SUBJECT: SURRY POWER STATION, UNIT 2 - AMERICAN SOCIETY OF MECHANICAL
ENGINEERS INSERVICE INSPECTION PROGRAM THIRD 10-YEAR
INTERVAL REQUESTS FOR RELIEF (TAC NOS. MC3140 AND MC3141)

SAFETY EVALUATION BY THE OFFICE OF NUCLEAR REACTOR REGULATION
RELATED TO THE THIRD 10-YEAR INTERVAL INSERVICE INSPECTION PROGRAM

SURRY POWER STATION, UNIT 2

3.0 SAFETY EVALUATION - Relief Request SR-034

FIG. 1 NOZZLE IN SHELL OR HEAD
 (Examination Zones in Barrel Type Nozzles Joined by Full Penetration Corner Welds)

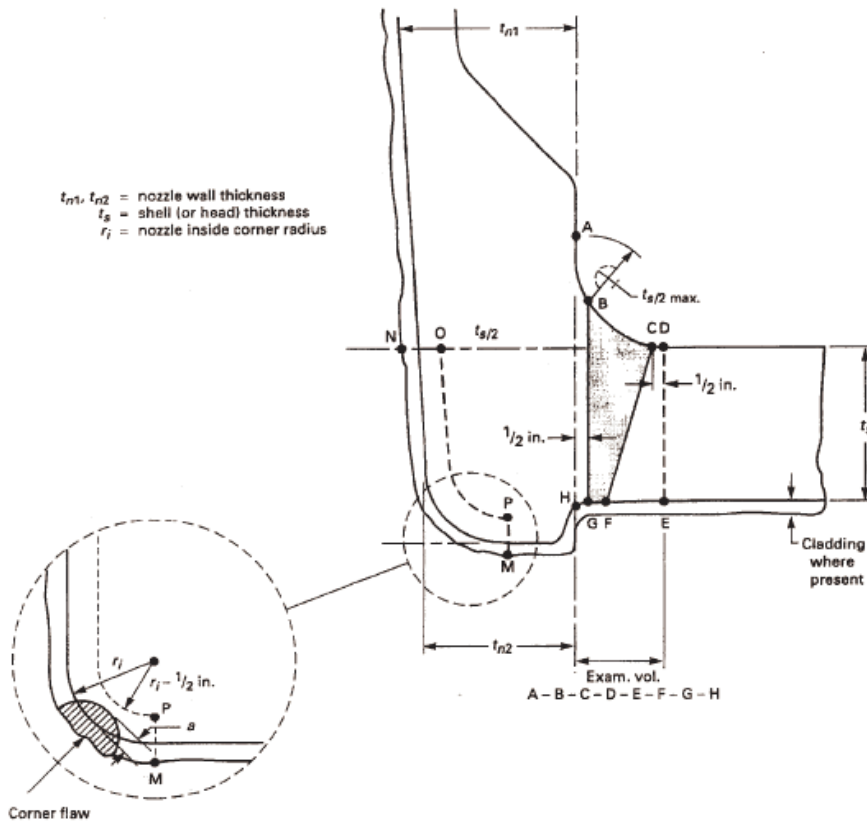
1. Perform examinations in accordance with the examination volumes defined in Figures 1 and 2 [See attached Figures 1 and 2].
2. Conduct Mechanized Ultrasonic Examinations of essentially 100% of all welds using PDI [Performance Demonstration Initiative] ASME Section XI, Appendix VIII qualified procedures and personnel. This will be accomplished in accordance with ASME Section XI, Division 1, 1995 Edition, 1996 Addenda, Appendix VIII, Supplements 4, 5, 6, and 7 as modified by 10 CFR 50.55a.
3. Periodic System Pressure Tests as per Category B-P, Table IWB-2500-1.

The attached Figures 1 and 2 provide an examination volume next to the widest part of the weld, which is reduced from one half of the vessel wall thickness to one-half ($\frac{1}{2}$) inch. This eliminates examination of vessel base material that was extensively examined during construction and pre-service inspections. Furthermore, the material is not in the high residual stress regions associated with the weld. The regions of high stress are located in the examination volumes that are defined in the attached figures and would be subject to examination by the proposed alternative. Note that the examination volumes depicted in the figures are the same as those included in ASME Code Case N-613-1, which was approved by ASME on July 30, 1998.

The licensee's proposed alternative addresses the area next to the weld that must be volumetrically examined. This alternative reduces the examination volume adjacent to the widest part of the weld from half of the vessel wall thickness to one-half inch. The thickness of the reactor wall near the nozzle is 9 inches, and the Code-required volume adjacent to the widest part of the weld from half of the vessel wall thickness would be $4\frac{1}{2}$ inches. The acceptability of reduced volume examinations is based on prior examinations of the base metal and the expected internal stress distribution near the weld. Although the alternative does not specifically impose prior examination results of the excluded volume area as a condition for allowing a reduced examination volume, the base metal was extensively examined during construction, preservice inspection, and inservice inspections. The licensee, in its letter dated May 13, 2004, indicated that these examinations showed that the ASME Code volume was free of reportable flaws.

The initiation of flaws during plant service in the volume excluded from examination by the licensee's proposed alternative is unlikely because of the low stress in the base metal away from the weld. The stresses caused by welding are concentrated at and near the weld. Cracks, should they initiate, will most likely occur in the high-stressed areas of the weld. The high-stressed areas are within the volume included in the licensee's alternative for examination. The licensee has performed prior examinations of the subject welds that support this aspect of its alternative. In addition, periodic system pressure tests per Category B-P, Table IWB-2500-1 will be performed that will provide assurance of leakage integrity of the components.

Based on the above discussion, the NRC staff has determined that the licensee's proposed alternative provides an acceptable level of quality and safety.

The NRC staff concludes that the licensee's proposed alternative provides an acceptable level of quality and safety. Therefore, the licensee's proposed alternative is authorized pursuant to 10 CFR 50.55a(a)(3)(i) for the remainder of the third 10-year ISI interval at Surry, Unit 2.
